HERITAGE VAUGHAN COMMITTEE – APRIL 21, 2021**COMMUNICATIONS****Distributed April 14, 2021**

**Re: Heritage Vaughan Committee – April 21, 2021, 2298118 Ontario Inc.
7714 Yonge Street, City File DA.14.009; Reginal File SP-V-016-14**

Report to the Heritage Committee regarding
RENOVATION OF THE EXISTING HERITAGE HOUSE ALONG WITH A
REAR ADDITION at 7714 Yonge Street.

PRELIMINARY
SITE PLAN

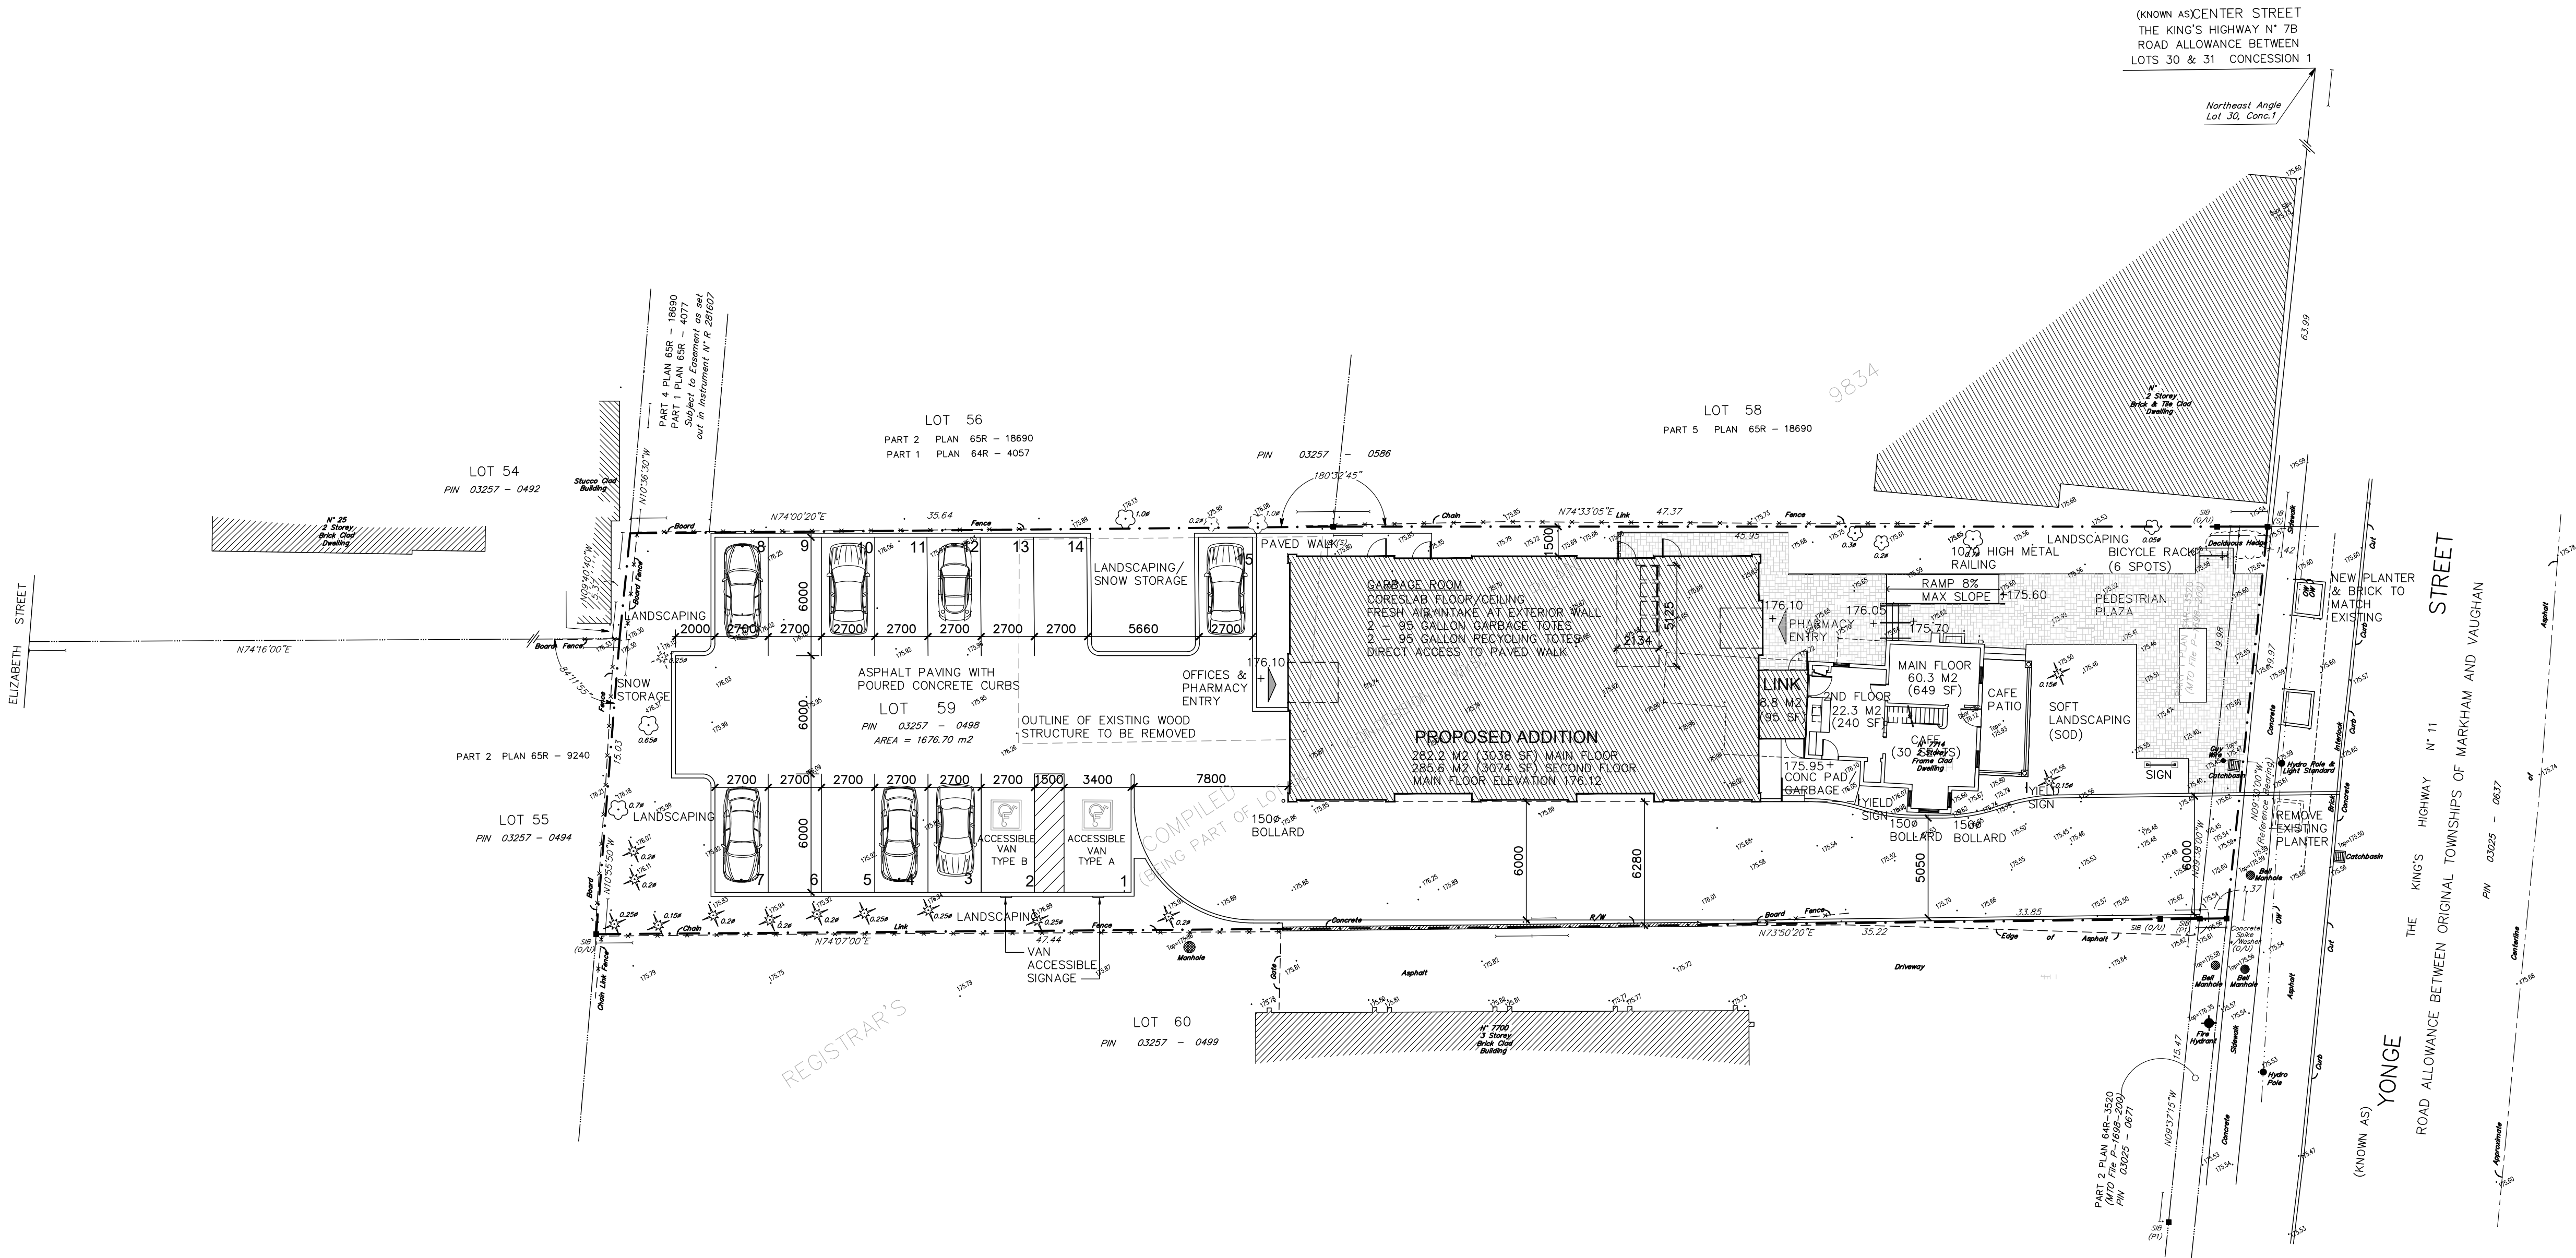
There were a number of comments raised at the meeting related to preservation of the trees on the site. As you are aware, we have worked diligently with staff over the last several years to retain as many of the trees on the site as possible. Steps include revisions to the site plan to preserve additional trees and the inclusion of such elements as the retention of existing concrete to protect tree roots where feasible and hand removal of these elements where retention is not possible. In addition, as outlined in the Arborist Report, the use of geocells and permeable materials is proposed. We are confident these measures will preserve as many of the trees on the site as possible.

There were also some comments suggesting that the driveway access be shared with the Bell building next door. However, we note that this option was explored early in the process and it was found that the existing grades on the site are such that a shared driveway is not feasible. Further, Bell Canada has previously raised liability issues. As a result, we were not able to provide for a shared driveway with Bell.

Additional comments were received which suggested the use of concrete barriers during the construction phase to prevent construction vehicles from accessing the rear of the property via the existing north driveway. We have no concerns with this suggestion and barriers can be included in the construction drawings at the appropriate stage in the approvals process.

We also note that the owner of property at 25 Elizabeth Street raised some concerns regarding construction impacts to residents of his coach house. We note that the proposed building is two stories in height and is located approximately 36 metres from the mutual property line. We further note that all landscaping and trees along the west and southwest

We also heard comments related to the amount of hard surface included as part of the proposed pedestrian plaza immediately adjacent to Yonge Street. Again, we wish to point out that significant effort has gone into planning for the creation of a pedestrian area which will enhance the Yonge Street urban fabric while encouraging members of the public to pause and enjoy the streetscape. We note that approximately half of the proposed pedestrian plaza will feature soft landscaping while the remaining area will be interlocked paving to facilitate mobility and access to the building. For clarity, the site plan has been revised to indicate that the landscape area in the front yard is intended to be soft surface. The rendering has also been updated to remove the north fence and more clearly identify the property line between the subject property and the property to the north.

We were also made aware of concerns regarding bird safety as it relates to the proposed one storey breezeway connecting the new construction. In response, we have made notes on the elevation plan that the breezeway is to include bird friendly glass to prevent bird injuries. Similarly, glass railings in the pedestrian plaza have been removed from the plan.

No	Date	Description	By
9	06 APR/21	SNOW STORAGE/RAILING	BA
8	15 FEB/20	ISSUED FOR SPA	BA
7	09 DEC/20	ADDED YIELD SIGNS	BA
6	08 DEC/20	REISSUED FOR SPA	BA
5	11 APR/17	ISSUED FOR SPA	BA
4	17 FEB/17	ISSUED TO CONSULTANTS	BA
3	13 FEB/17	ISSUED FOR REVIEW	BA
2	10 FEB/17	ISSUED FOR REVIEW	BA
1	03 FEB/17	ISSUED FOR REVIEW	BA

TREE PRESERVATION PLAN

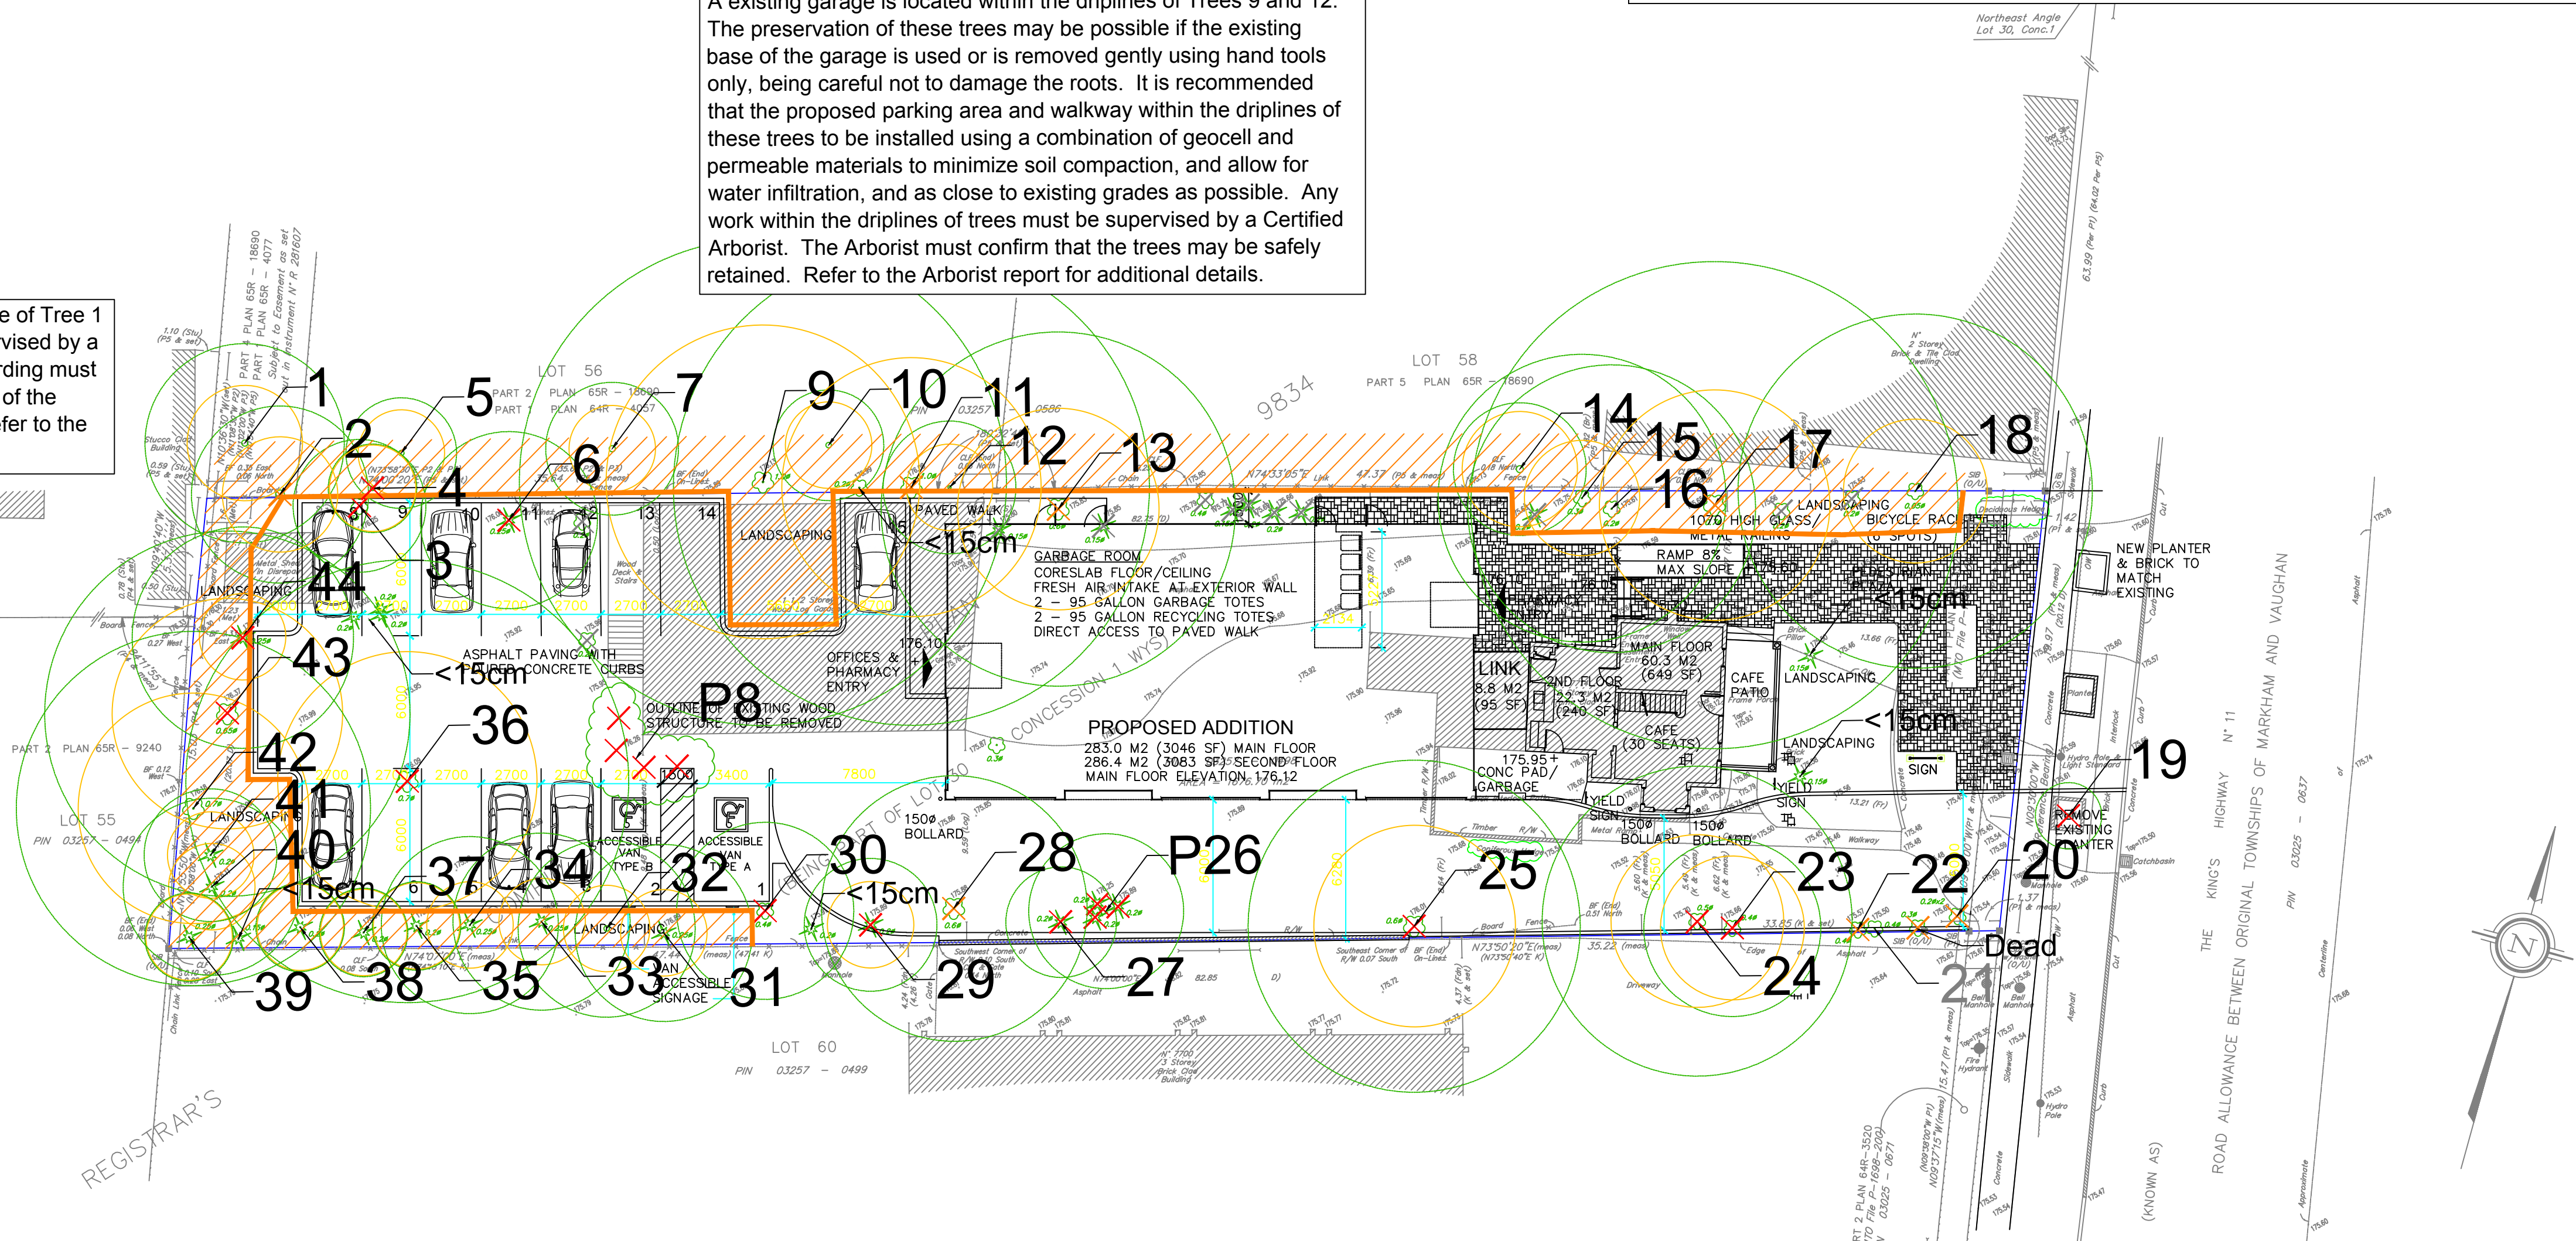
A existing garage is located within the driplines of Trees 9 and 12. The preservation of these trees may be possible if the existing base of the garage is used or is removed gently using hand tools only, being careful not to damage the roots. It is recommended that the proposed parking area and walkway within the driplines of these trees to be installed using a combination of geocell and permeable materials to minimize soil compaction, and allow for water infiltration, and as close to existing grades as possible. Any work within the driplines of trees must be supervised by a Certified Arborist. The Arborist must confirm that the trees may be safely retained. Refer to the Arborist report for additional details.

The concrete pad located within the dripline of Tree 1 is to be removed gently by hand and supervised by a Certified Arborist. The tree protection hoarding must be installed immediately following removal of the concrete pad and prior to construction. Refer to the Arborist report for additional details.

Encroachment into the driplines of Trees 1, 12, 14, 18, 31 to 35, 37, and 38, will be required to accommodate the proposed parking area, walkway, and/or hardscape. Any required excavation should be conducted by hand, air spade or hydro-vac to expose roots for assessment and pruning. It is recommended that the proposed surfaces within the driplines of these trees to be installed using a combination of geocell and permeable materials to minimize soil compaction, and allow for air and water infiltration, and as close to existing grades as possible. Any work within the dripline of trees should be supervised by a Certified Arborist. The Arborist must confirm that the trees may be safely retained. Refer to the Arborist report for additional details.

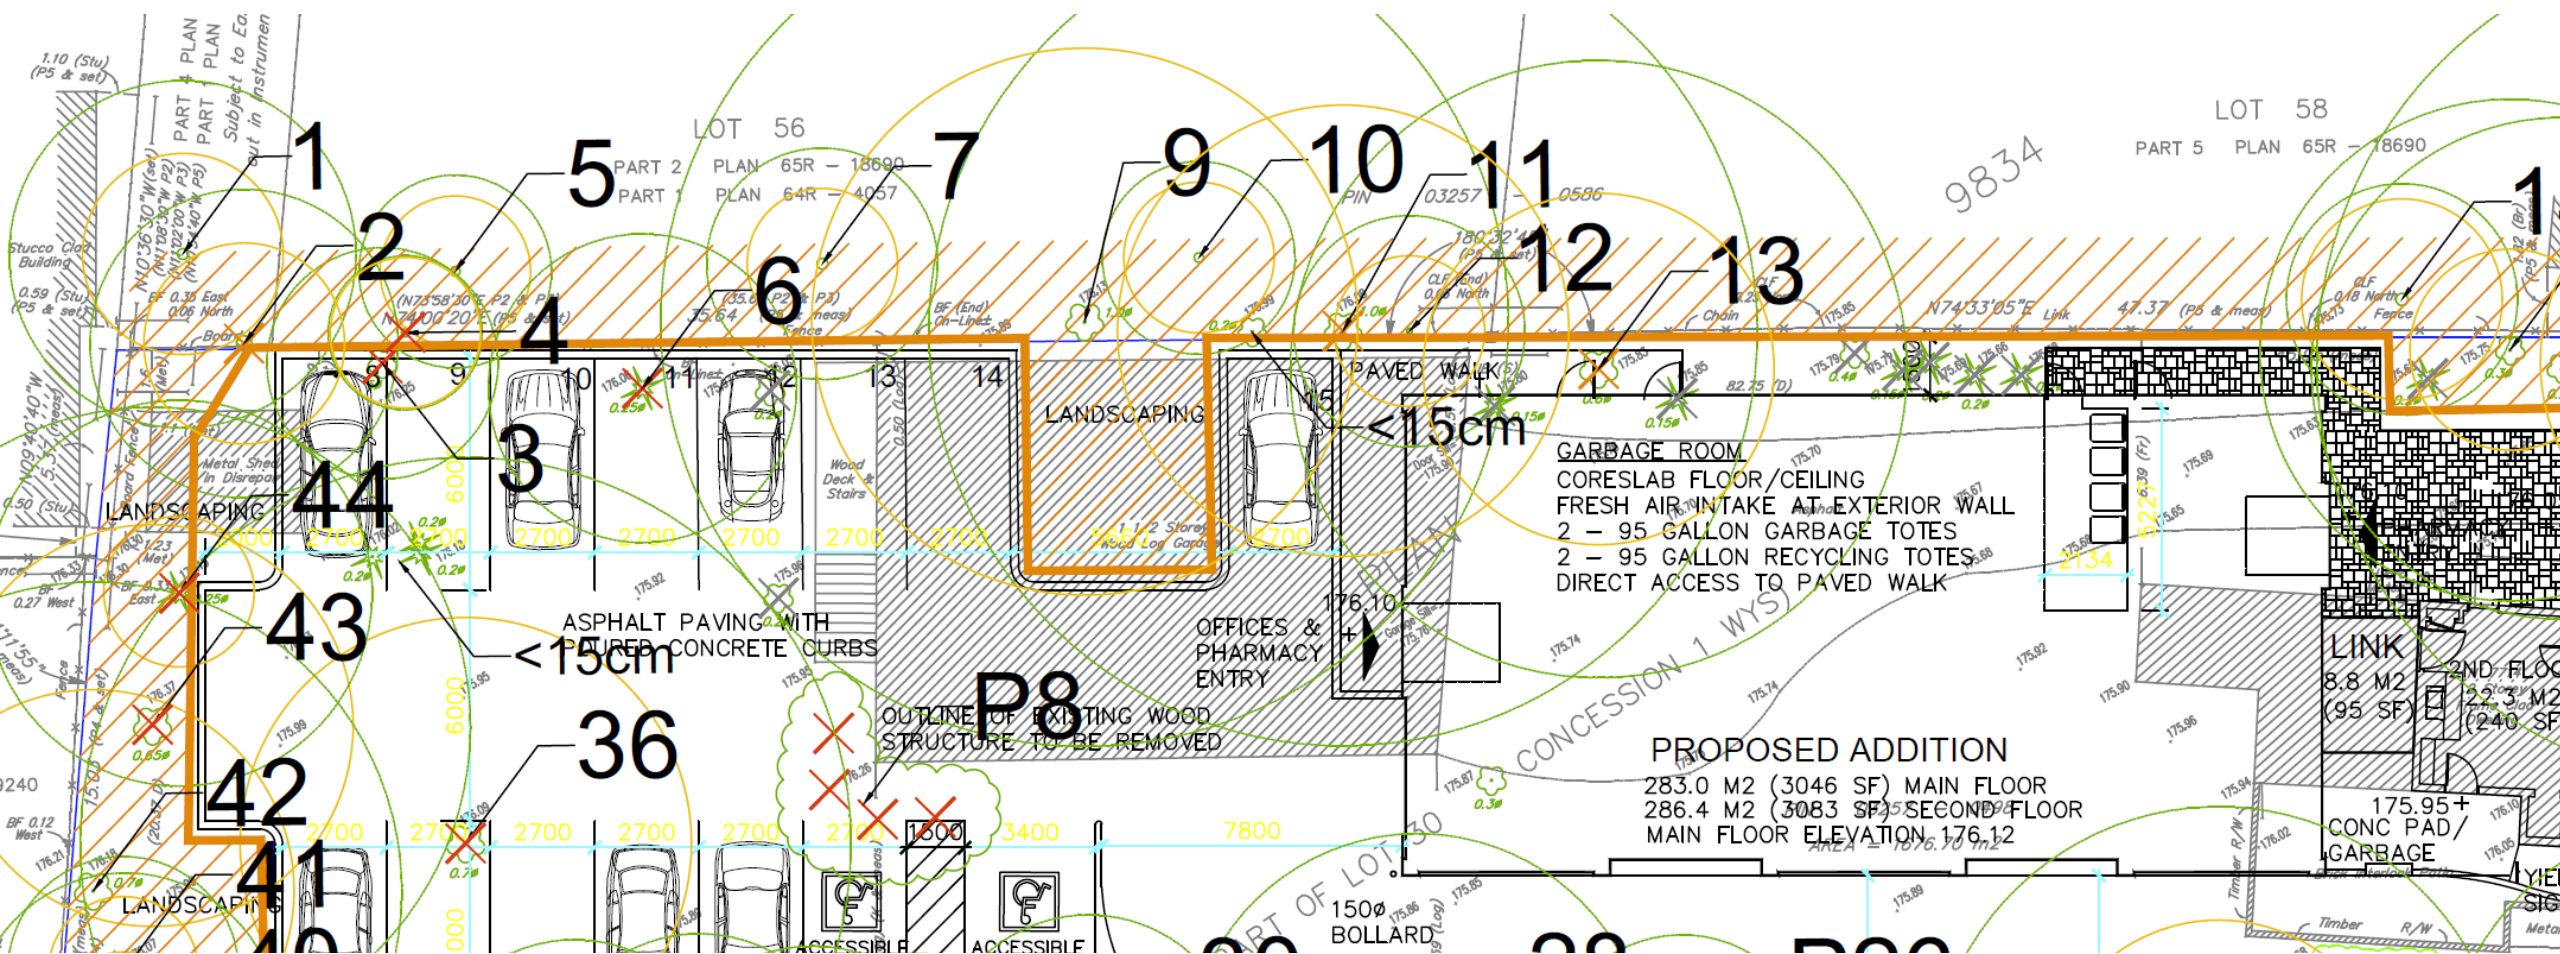
- Inconsistencies between the two arborist reports provided.
- Unconsented recommendations on shared trees in Amy Choi report.
- Inappropriate recommendations on trees that are fully on my property.
